31/07-05I 10009 Menlo Ave
Capitol View Historic District

CASE NO. A-6152

Memorandum**Date: September 5, 2006****To: Tania Tully, Historic Preservation Planner****From: Bill Karas****Info: Eric Gronning****Re: 1009 Menlo Avenue Variance Request****Case No. A-6152**VIA FAX

TO: Robert Hubbard, Director
FROM: Tania Tully, Senior Planner
Historic Preservation Section
SUBJECT: Historic Area Work Permit #397538

REVISED DRAWINGS

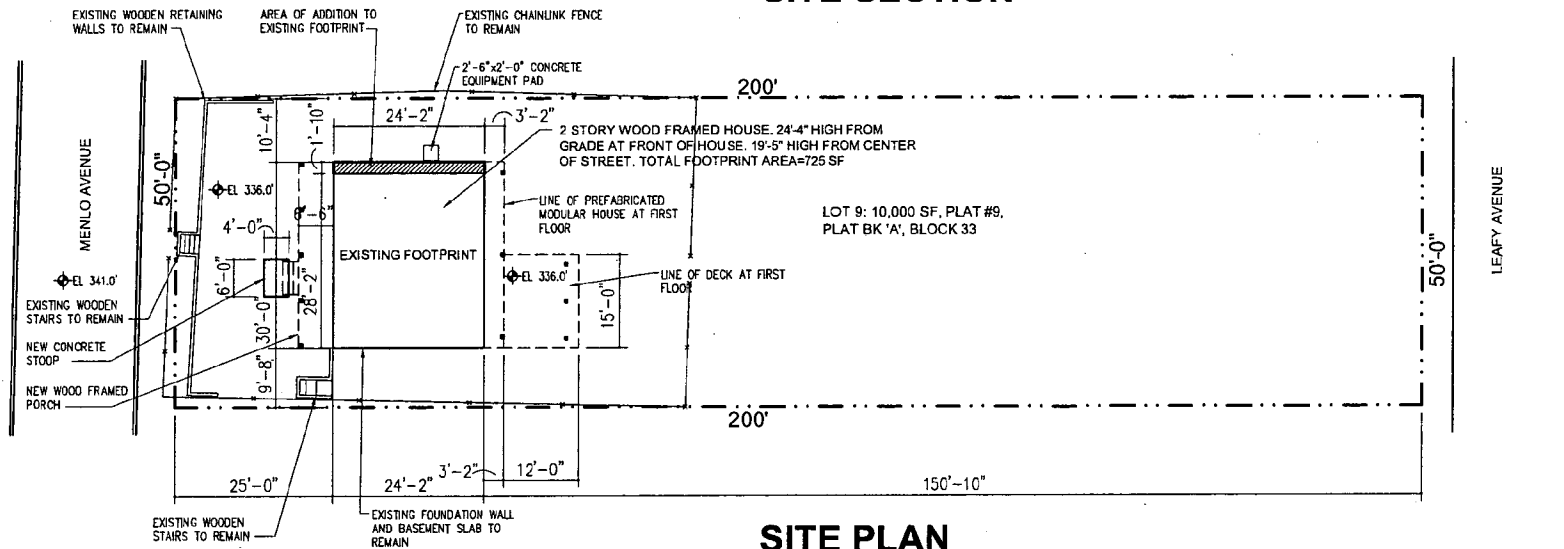
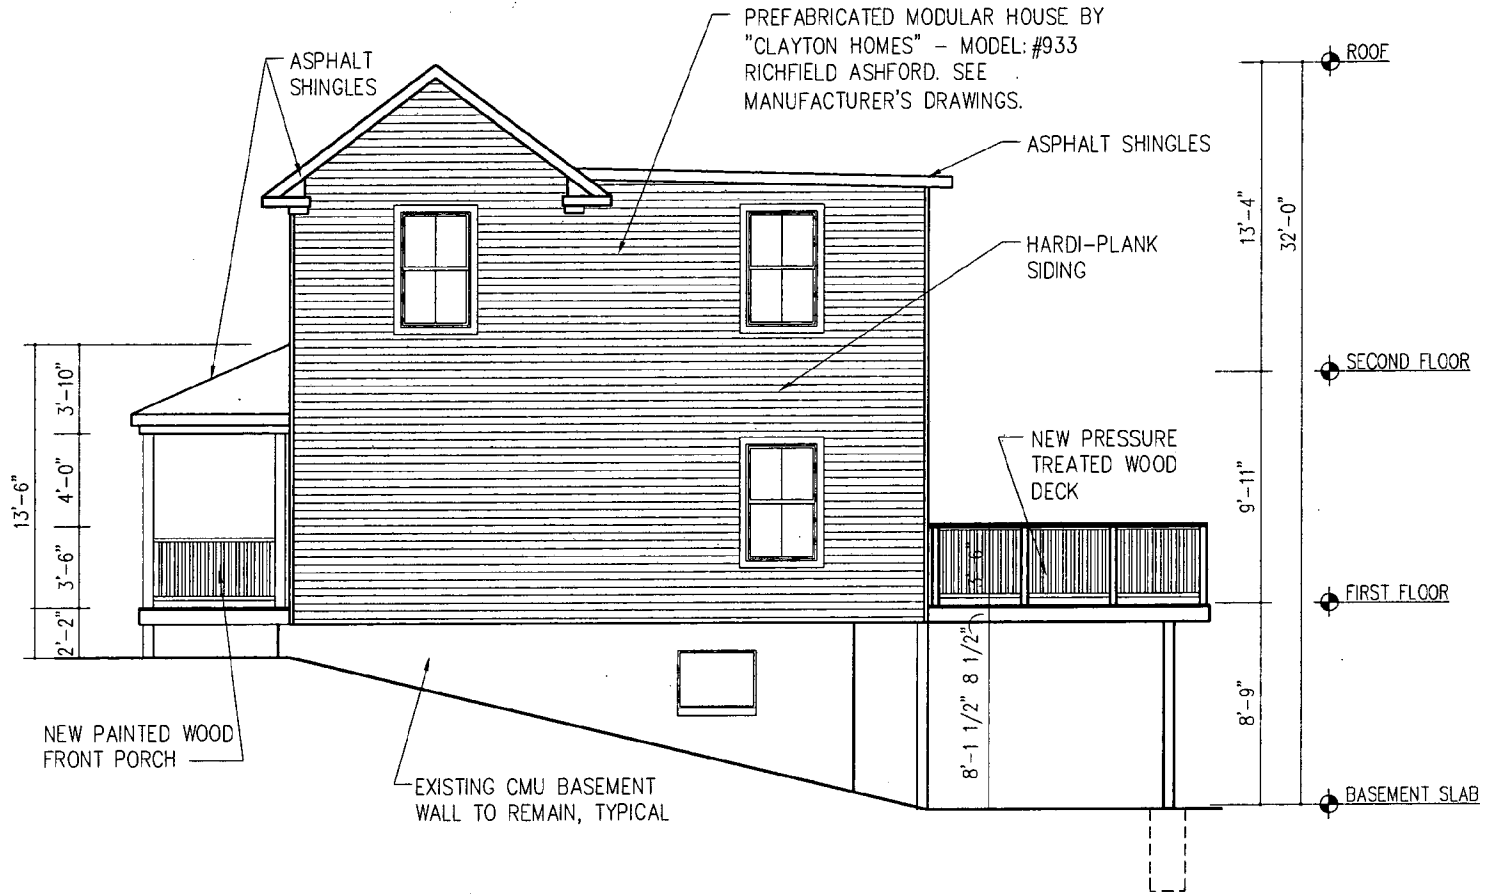
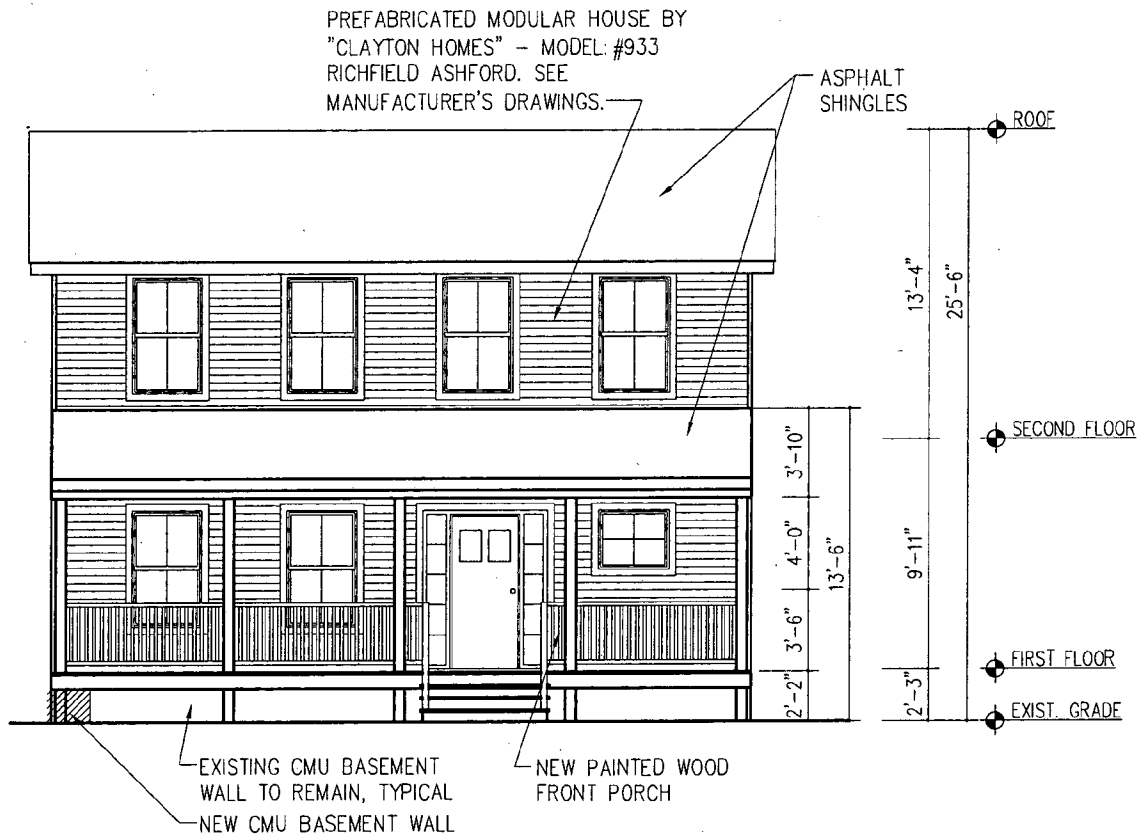
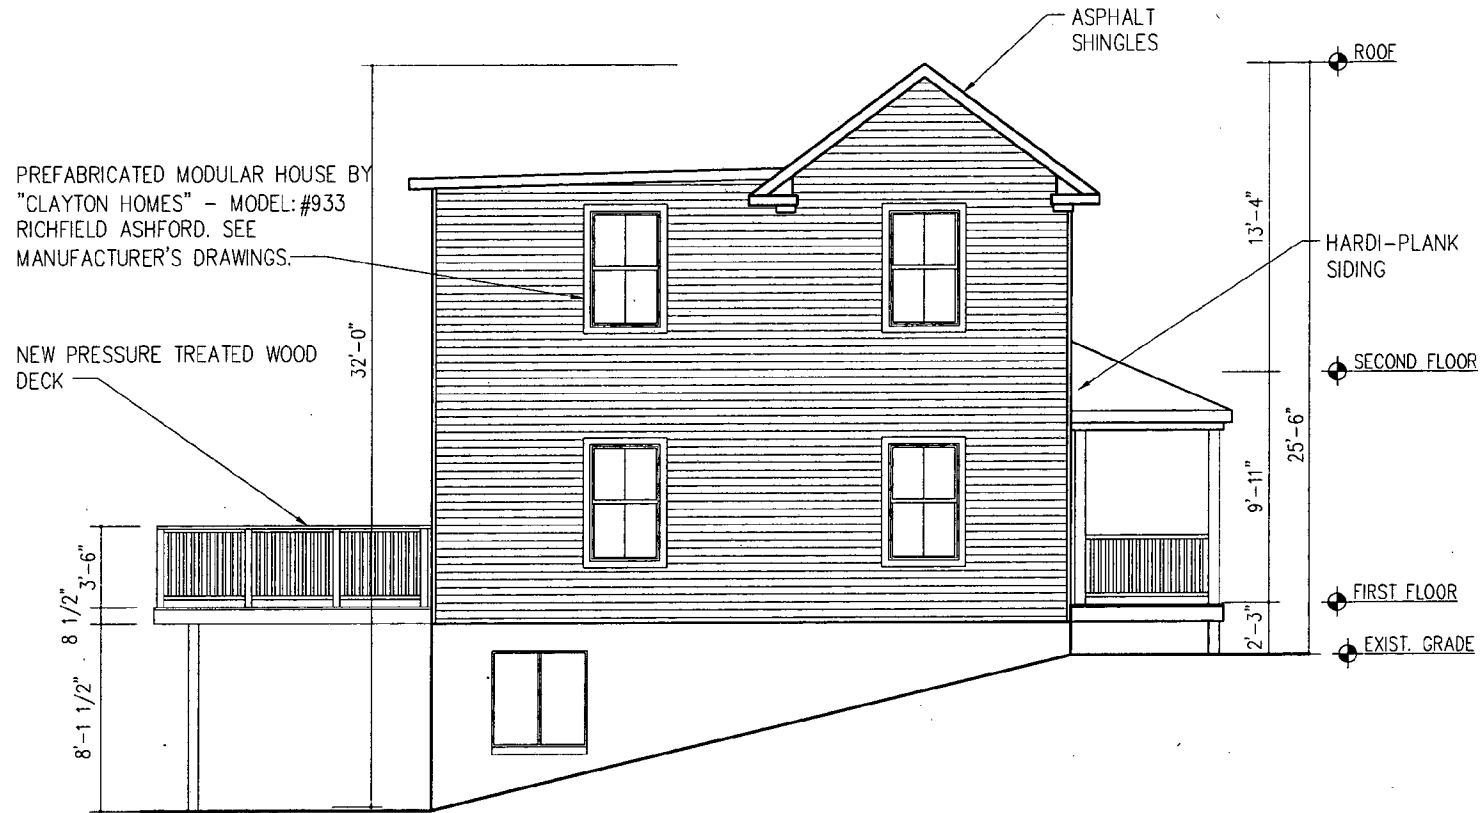
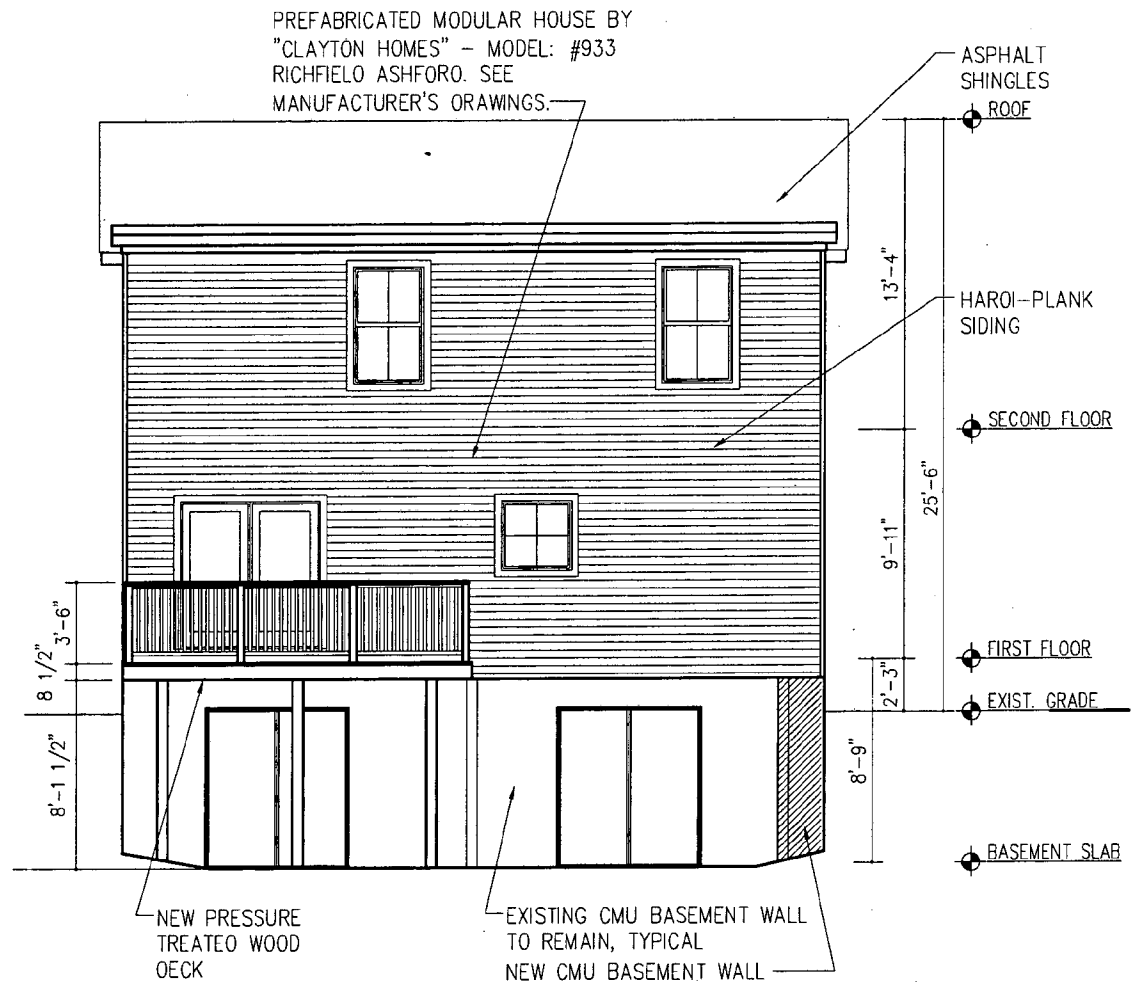
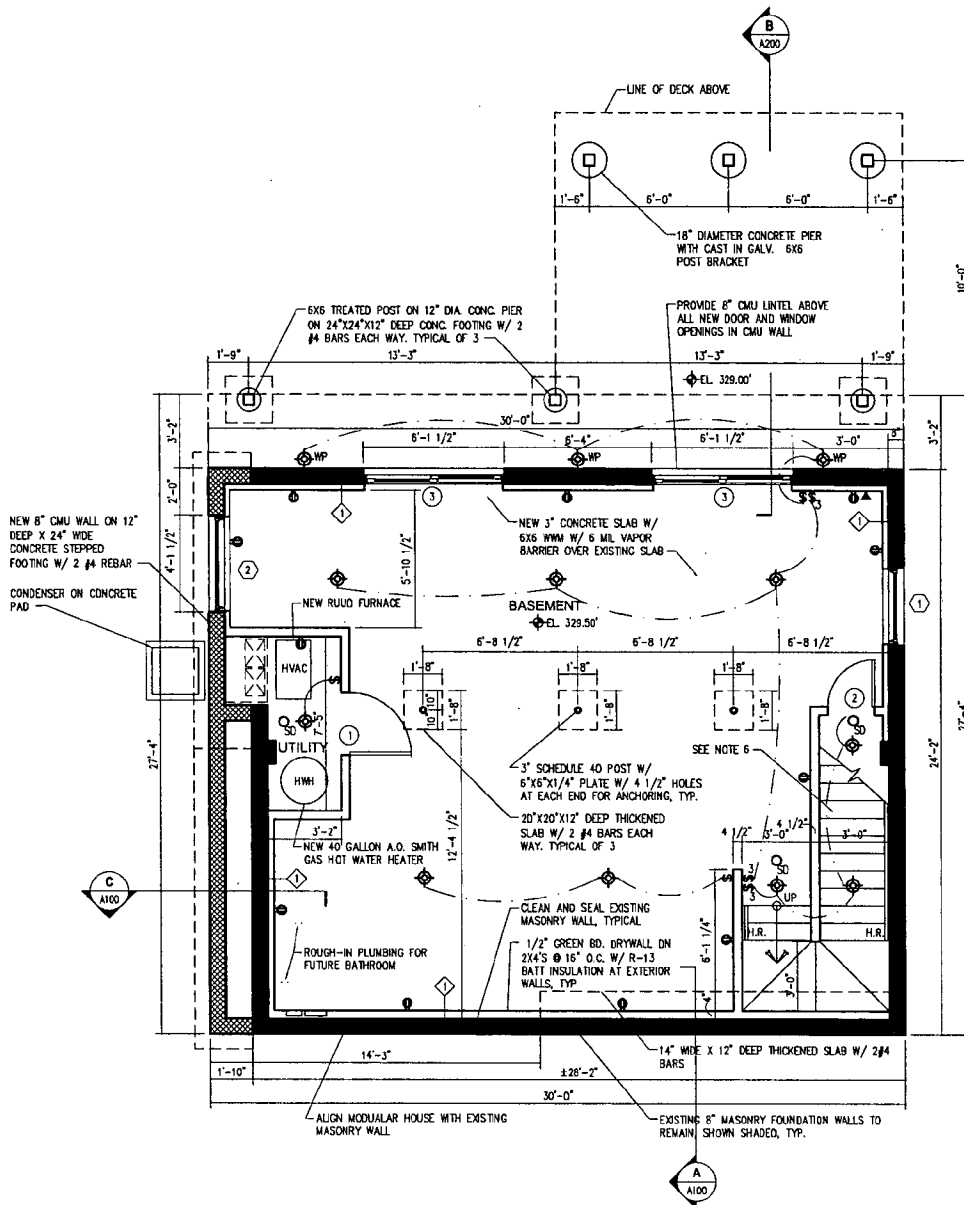
We have revised the residence per your suggestions and the staff suggestions as outlined on the HISTORIC PRESERVATION COMMISSION STAFF REPORT dated 11/9/2005. We have incorporated all but one of your suggestions as outlined below. Thank you for your recommendations, we believe that the revised scheme is significantly better than from where we started.

1. The windows have been regularized.
2. A rectangular window has been added to the right of the door.
3. The steps are located across from the front door.
4. The paired window on the left elevation is now a single. We could not add a window to the right side because it would be in the stair stringer.
5. The roof line has been modified per your sketch and the overall building height is at 25'6" above grade
6. Details to follow after approval.
7. Tree protection will be in place prior to work as approved by hpc.
